FINAL ENVIRONMENTAL IMPACT STATEMENT

PINE BEND SANITARY LANDFILL EXPANSION

INVER GROVE HEIGHTS, MINNESOTA

Pine Bend Sanitary Landfill
Draft EIS Comments
June 9, 1980

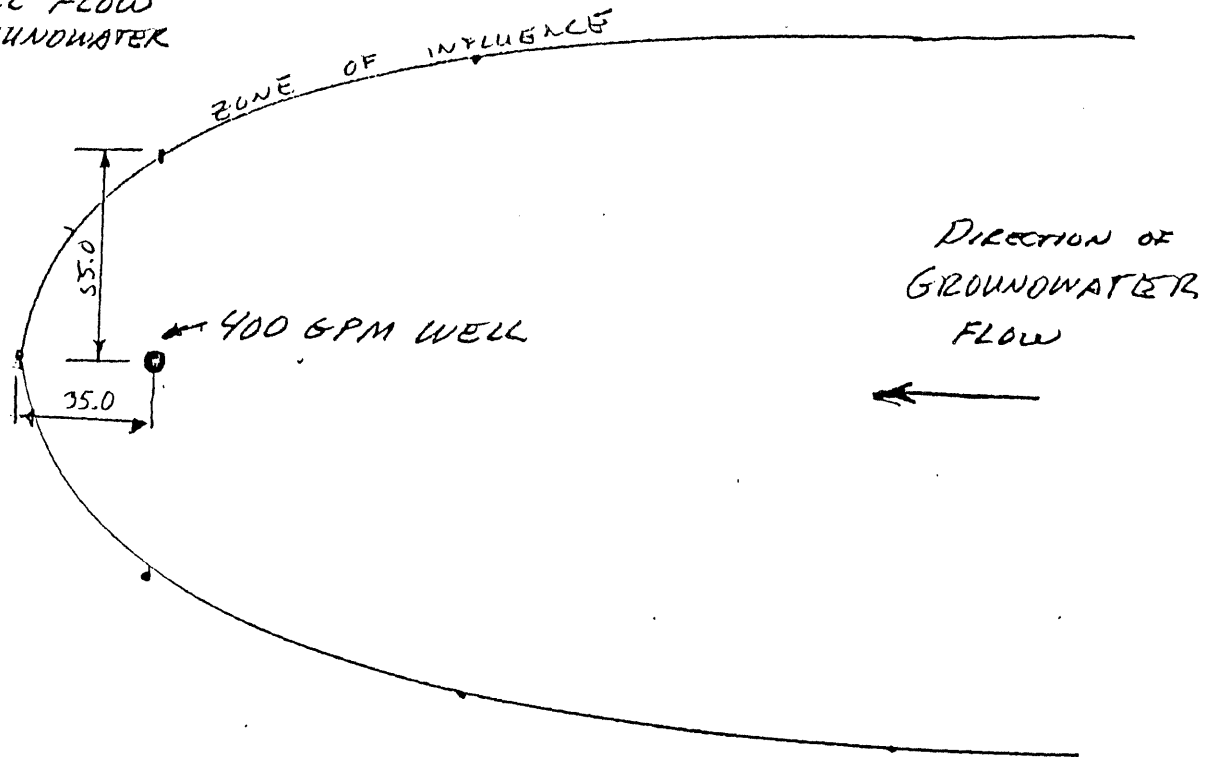
We estimated the effect of installation of wells in the proposed residential subdivision to the northwest of the American Hoist Bale Fill. To do this, we used a worst case analysis assuming that the entire subdivision would be serviced by one well located near to the bale fill border. The rate of pumping for one hypothetical site well is the equivalent of 20 average residential wells. Assumptions for the well and groundwater system at the site were as follows:

Well pumping rate (steady)	=	400 gpm
Hydraulic conductivity of aquifer	=	130 ft/day
Groundwater gradient	=	.0106 ft/ft.
Thickness of aquifer	=	250 ft.

The hydraulic conductivity is from the groundwater study for the landfill (Sunde, 1978). The groundwater gradient is an average of the gradient cited in the above study and estimates by John Curry of gradients in the subdivision area.
